**DESIGN RECOMMENDATION  
MEETING- NORTHEAST DRB**

APRIL 15, 2019

UNION BAY PLACE APARTMENTS

SDCI PROJECT #3030253

2.a.

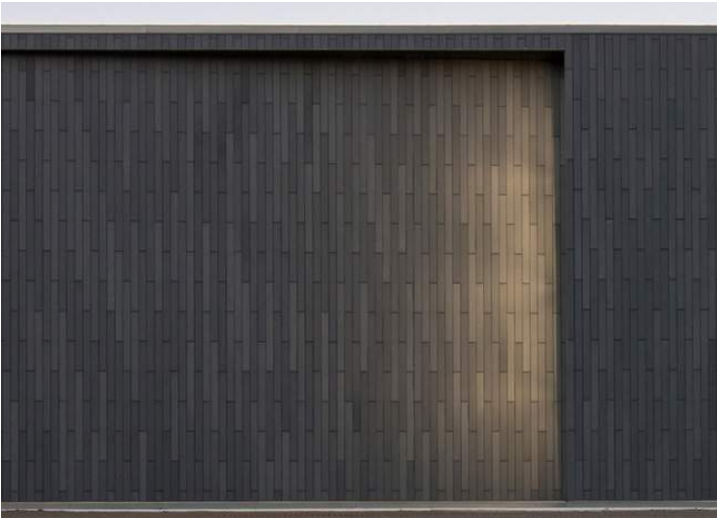
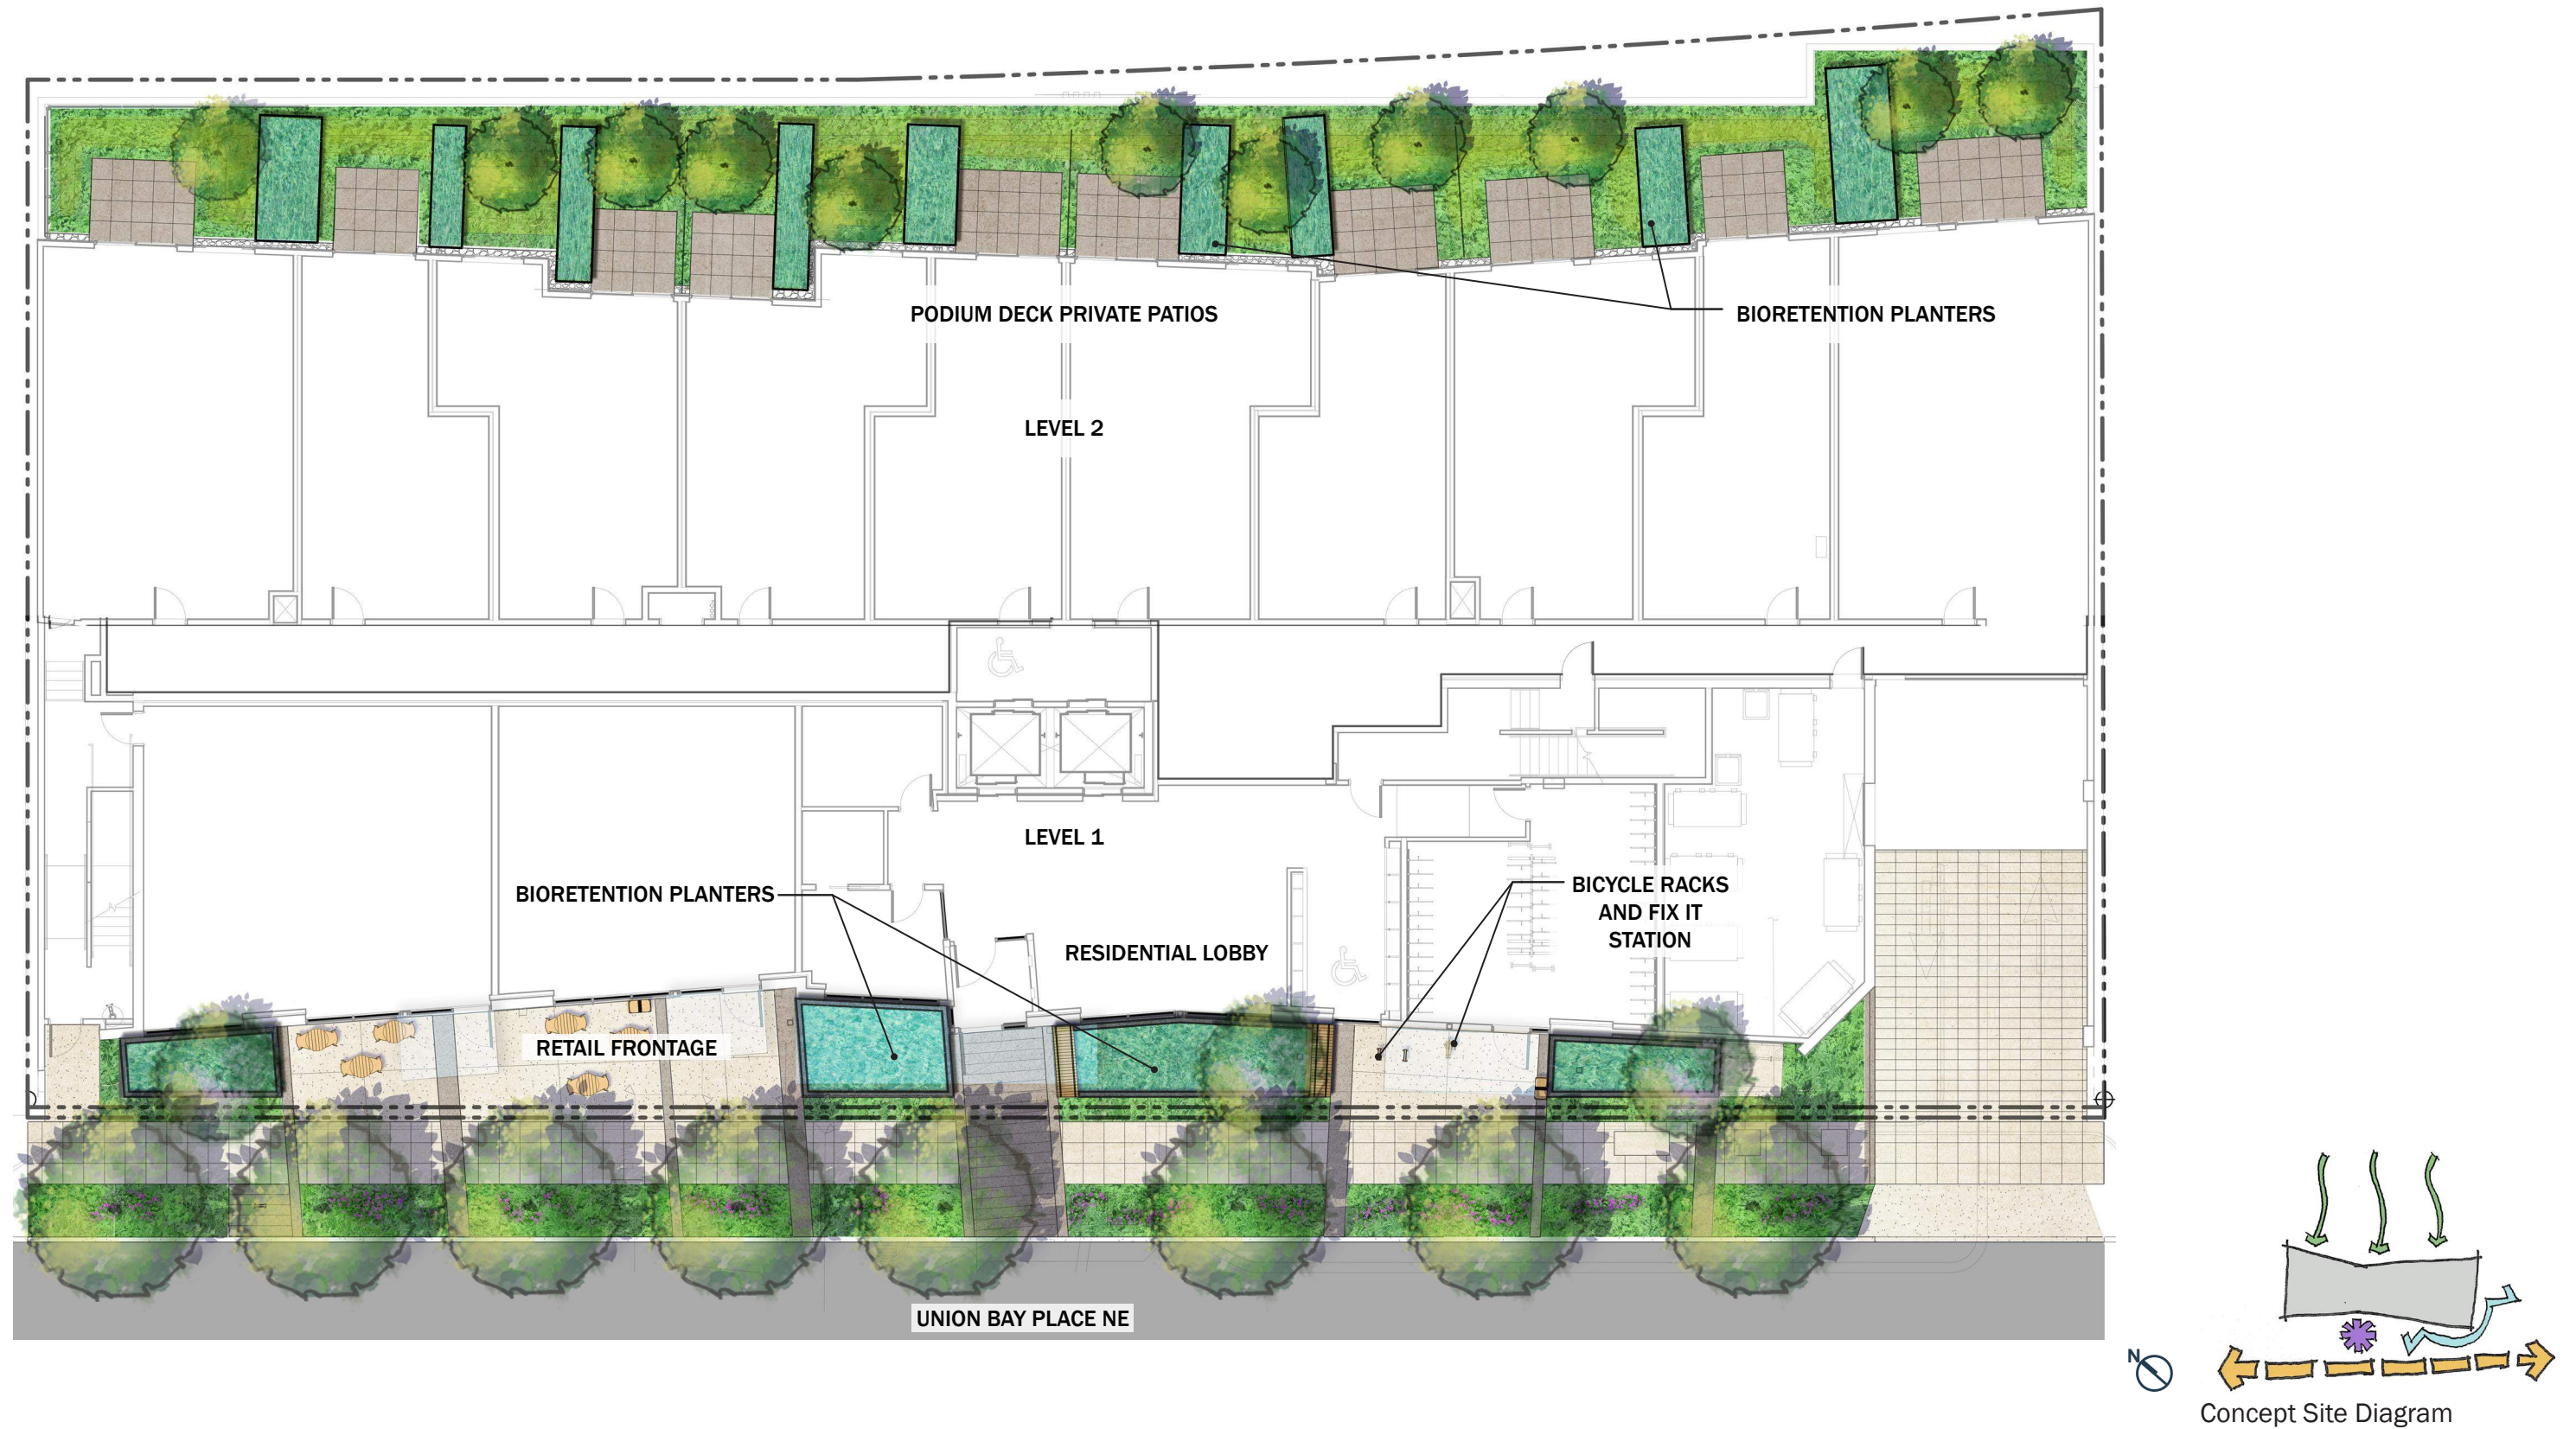
The bend in the west elevation was identified as an integral part of the architectural concept, adding an element of interest. The Board recommended attention to detail in the treatment of this bend.

The Recommendation packet (pages 20-23) contained a historic analysis of the area, outlining how this context, including the rail spur line, lumber mill on Union Bay, and area circulation patterns informed the massing. The Board appreciated this attention to detail and encouraged the project to incorporate these historic references in the architectural concept in subtle and obvious ways. (CS3.B Local History and Culture)

② Wood grain fiber cement soffits recur along the entire length of the building in a 3 foot deep soffit tying the retail plaza to the lobby and the rest of the building. This soffit will be lit with similar LED up-lighting creating an inviting warm glow at the pedestrian level. Interior wood ceilings in the lobby pull this warmth inside. The bent form of the building creates generous open space at grade for public uses. The planting palette at grade references the nearby Union Bay Natural Area, once home of the mill, using grasses and seasonal flowering perennials.

③ Landscape features continue in the paving. The main entry is accented with tighter board-like bands reminiscent of the docks and train platforms around the mill and the small train station that occupied the split off of the spur line. Splash blocks within the rain gardens are piles of rough sawn timbers as you would find around the old mill. These will be noticeable features as all the water from the west roof travels down exposed rain leaders to fill these planters on stormy days. (CS1-E-2 Adding Interest with Project Drainage.) See p.28 for landscape images.

④ Wood benches detailed similarly to the rail - trellis extend off of the rain gardens near the lobby and the public bike maintenance station. Here, in front of the blank wall hiding the trash room, two large resin panels in complementary wood tones display graphics of historic maps of Union Bay showing the rail spur line and the mill-era neighborhood.

#### 2.c

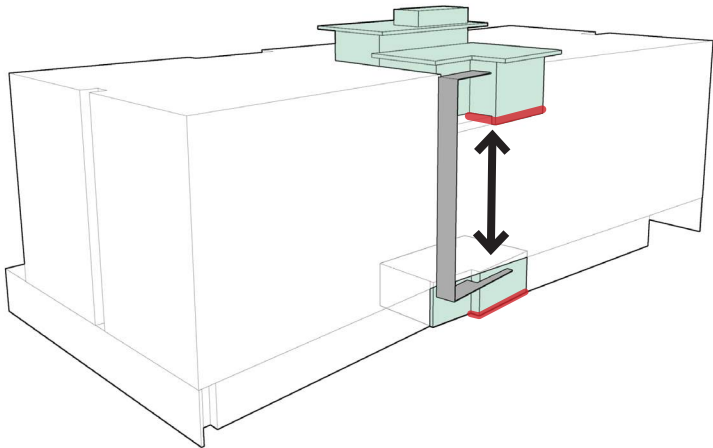
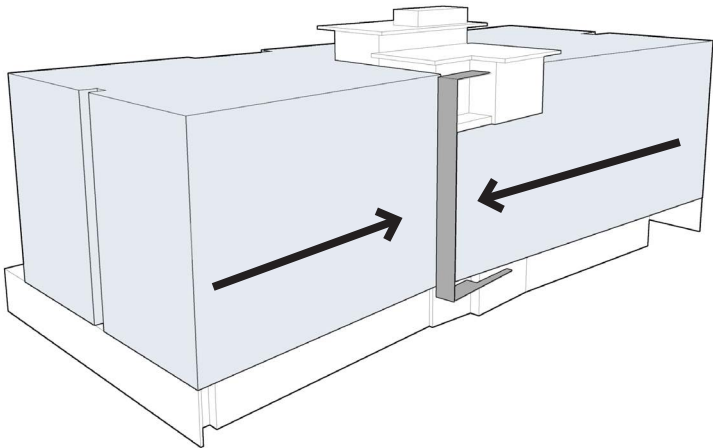
2.c. A roof deck was proposed at the southwest portion of the roof, overlooking Union Bay PI NE. The Board supported this location of this amenity space to take advantage of views and physical connections to exterior spaces and uses, and recommended it be visually linked to the residential entry below and incorporated into the façade composition. Concepts of light and elements of verticality were suggested. The Board also requested additional details describing the landscape plan. (DC1-A-4 Views and Connections, DC2-B Architectural and Facade Composition)

The roof deck is at the SW corner of the building to capture views, and to provide some separation and privacy to the residential neighborhood to the east as noted in 2.b response (CS2-D-5 Respect for Adjacent Sites). It is connected physically to the club room at level 6 via the elevator lobby and an internal feature stair. It is connected visually to the club room via clerestory windows in the popped up roof of the club room (DC1-A-4 Views and Connections). Similar overhangs appear on the elevator lobby penthouse that also serve to break down the scale of this necessary projection.
